2005 6.0L DIT RUNNING CHANGES

VGT Control Valve Connector

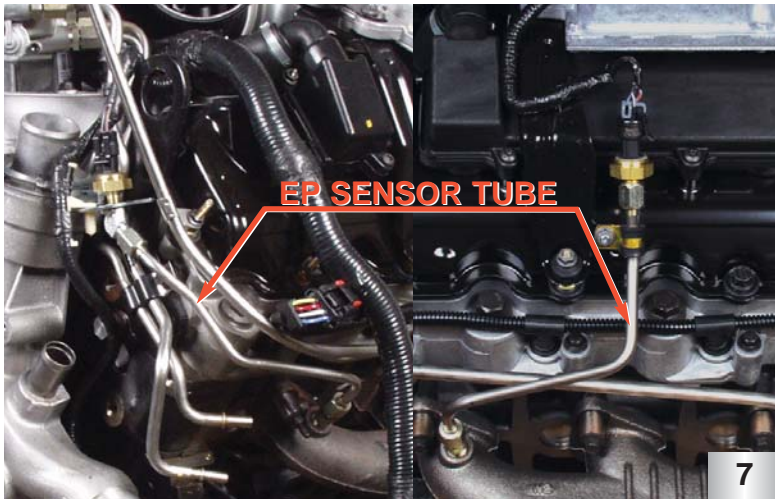
- The engine sensor harness has received several changes during the 2005 MY. Most of the changes have been made to reduce chafe points and provide more secure connections.
- One noticeable change is a new VGT control valve connector.
- The new connector will provide a more secure connection to the VGT control valve.
- **NOTE: The VGT control valve did not change.**

Exhaust Pressure Sensor Relocation

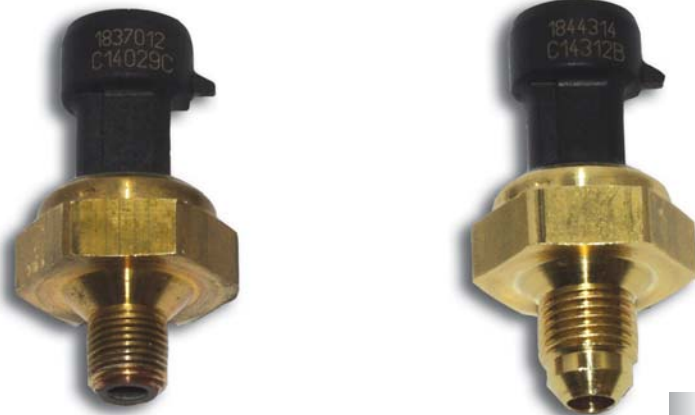
- The Exhaust Pressure (EP) sensor has been relocated to the FICM bracket.
- This change requires a new EP tube and FICM bracket to be used.
- The engine sensor harness had to be lengthened to accommodate the new sensor location.
- **NOTE: It is important to secure the nut on the EP sensor tube when removing the EP sensor.**

Water Pump Pulley

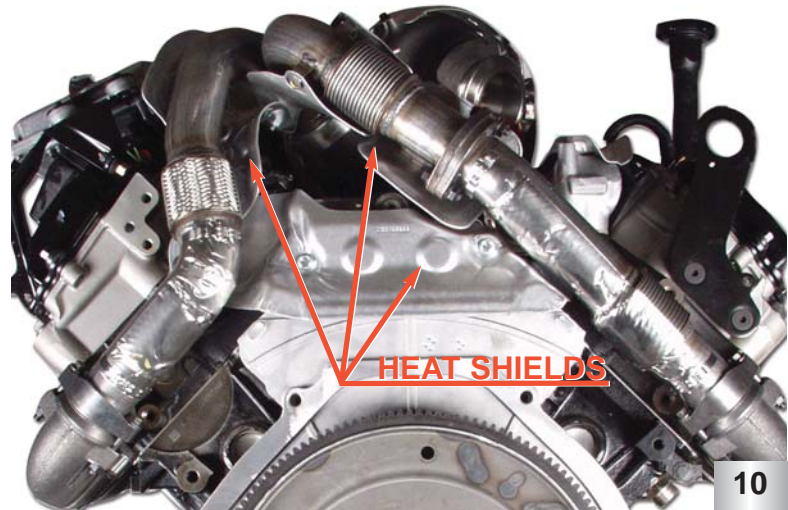
- The water pump pulley has been made more robust with the use of a thicker flange.
- The new water pump pulley design does not require the separate flange support plate as used on the previous design.

Current Style Rear Heat Shield

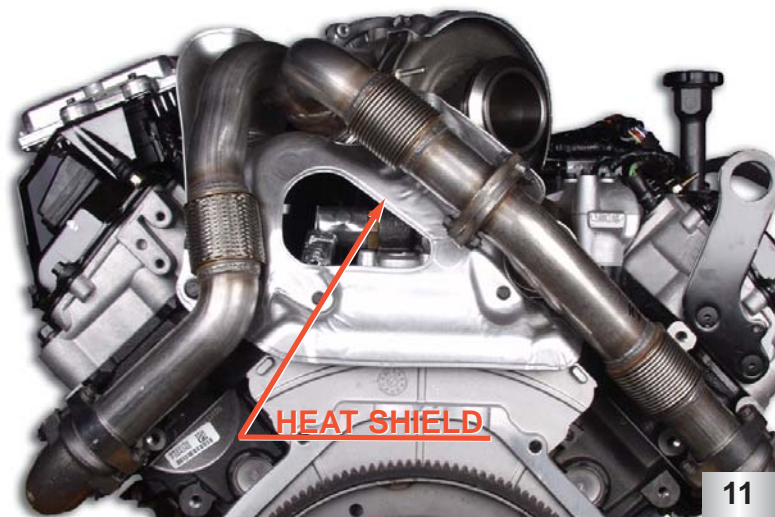
- The three heat shields on the 2003, 2004, and early 2005 MY engines have now been incorporated into one large heat shield.
- The new heat shield attaches to the high-pressure pump cover, left hand cylinder head and to the intake manifold.

Optimized Exhaust Pressure Sensor

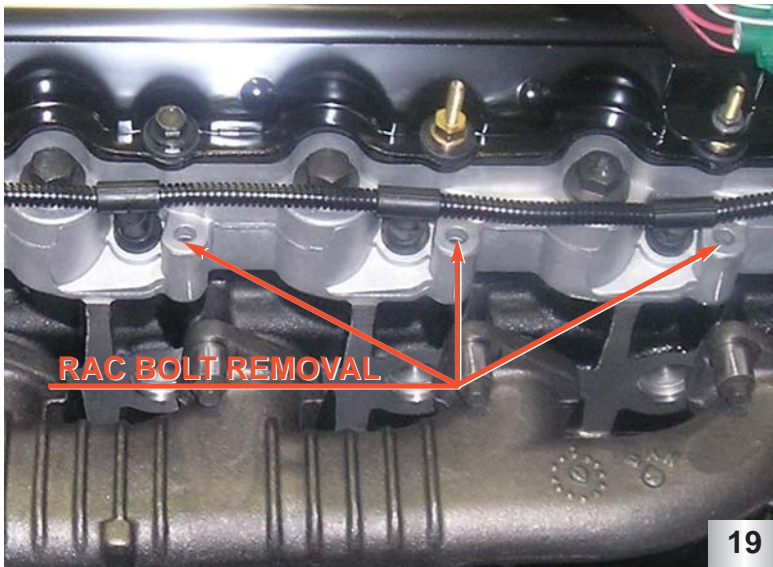
- A new Exhaust Pressure (EP) sensor went into production on January 14, 2005.
- The new sensor incorporates an improved ceramic sensing disc that is less susceptible to exhaust corrosion.
- The optimized sensor can be identified by the International part number 1850353C1 or 1850352C1 located near the top of the sensor body.
- **NOTE: The optimized EP sensor is available as a service part for 2003.25, 2004.25, and early 2005 MY engines which use different mounting threads.**
